Amendments to the Drawings

Remarks

Drawing Objection

FIG. 3

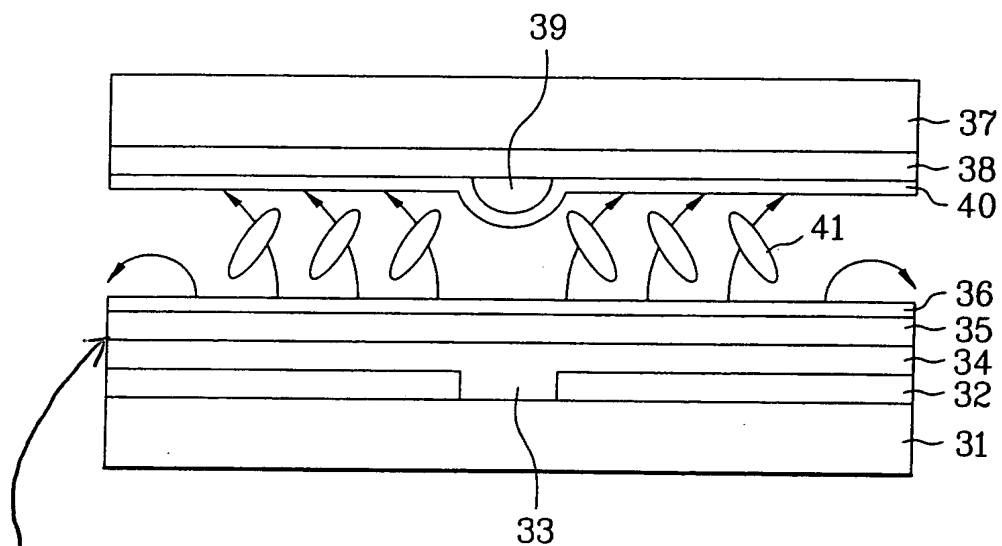
Fig. 3 has been amended to show the location of a thin film transistor and passivation layer feature.

The drawing is objected to under 37 CFR §1.83(a) for not showing every feature in the claims. This objection is respectfully traversed.

Nevertheless, Applicants have amended Fig. 3 to show the location of a TFT and a passivation layer, as described in paragraph [0040], for example,

showing the recited TFT as a labeled representation because a more detailed illustration is not needed for a proper understanding of Applicants' claimed invention. No new matter is involved.

TFT & Passivation Layer
